TRANSMITTAL OF REPORT ADDRESSING KEY TECHNICAL ISSUE (KTI)
AGREEMENT ITEM TOTAL SYSTEM PERFORMANCE ASSESSMENT AND
INTEGRATION (TSPAI) 3.03

RESPONSE TO TSPA AGREEMENT 3.03

Enclosure
Response to TSPAI Agreement 3.03

Figure 1. Sensitivity of Mean Annual Dose to the Drip Shield Performance TSPA Model Component²

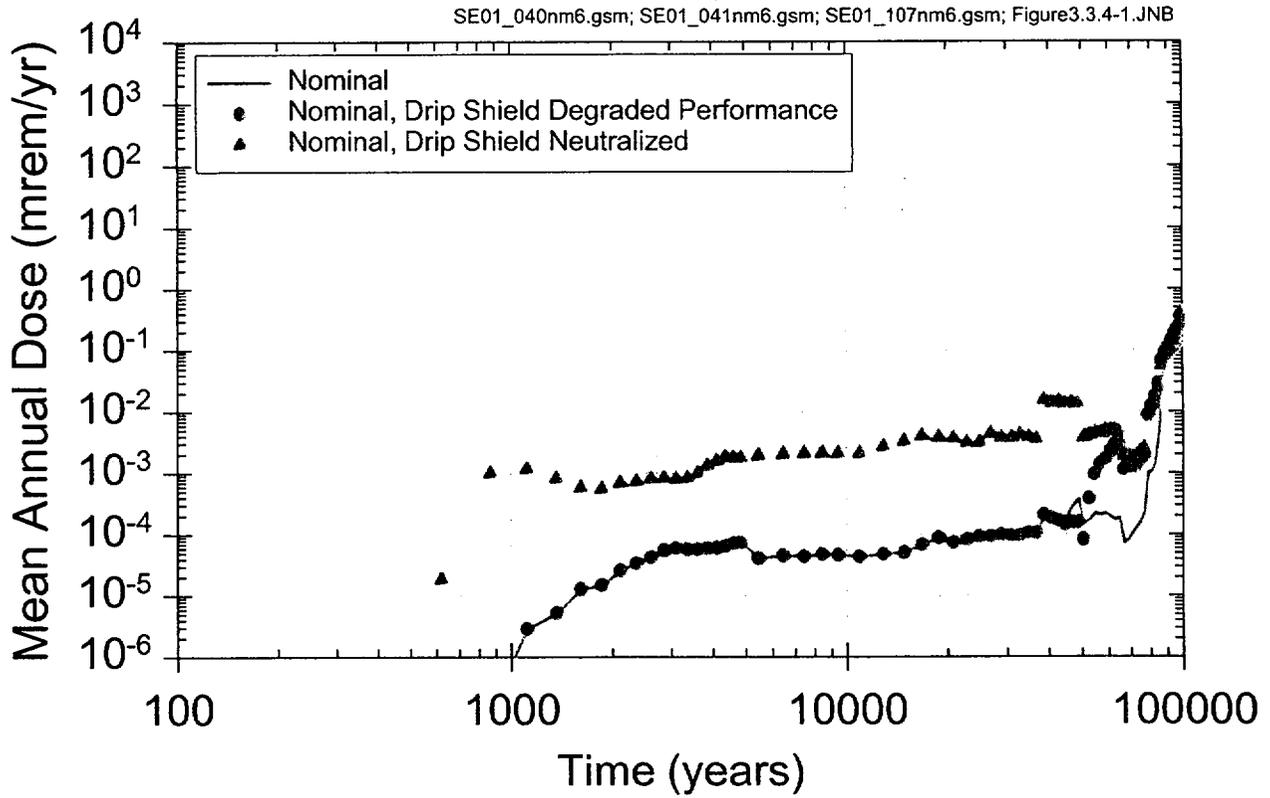
In the August 2001 TSPAI Technical Exchange (Reamer, C. W. and Gil, A. V. 2001), the NRC commented that the DOE model abstraction for the transport of water through stress corrosion cracks in the drip shield and diffusive transport of radionuclides through the stress corrosion cracks in the waste packages assumes that the quantity of water that is transported through cracks in the titanium alloy drip shield is limited by diffusion. Therefore stress corrosion cracking of the drip shield has been excluded as a feature, event or process (FEP) on the basis of low consequence because water transport through cracks in the drip shield will not significantly increase the quantity of water contacting the waste packages and waste forms. The NRC noted that the DOE assumption of diffusive transport of radionuclides with the exclusion of advective transport relies on stress corrosion crack geometries that will remain tight for thousands of years. The NRC concluded that the tight geometry of stress corrosion cracks is based on unsupported assumptions and therefore DOE needs to provide the technical basis for the tight crack geometries that prevent advective transport through stress corrosion cracks in the drip shield.

Two studies were considered. The first study examined the impact of an aggressive drip shield corrosion rate. The general corrosion rate of the drip shield material was enhanced by a factor of more than five¹. This enhanced rate is outside the range of uncertainty represented in the reference model and is chosen to test the sensitivity to extreme and unrealistic conditions. As shown in Figure 1 by the degraded drip shield performance curve, even at the higher corrosion rate, none of the drip shields are expected to fail due to corrosion before 10,000 years. As a result, the estimate of mean annual dose in the first 10,000 years is not affected.

The second study considers a more extreme representation of drip shield degradation in which the barrier function of the drip shield is assumed to be completely breached at the time of permanent closure. Figure 1 shows that with the drip shields neutralized, an increase in the estimated mean annual dose occurs due to the fact that the drip shields provide no effective barrier to water contacting the waste packages in the study. The associated increase in mean annual dose is calculated to be less than 0.001 mrem/year due to an increased rate of release of radionuclides from the waste packages that are breached. These results indicate that breaching of the drip shield due to SCC or other degradation modes does not have a significant impact on the estimate of mean annual dose.
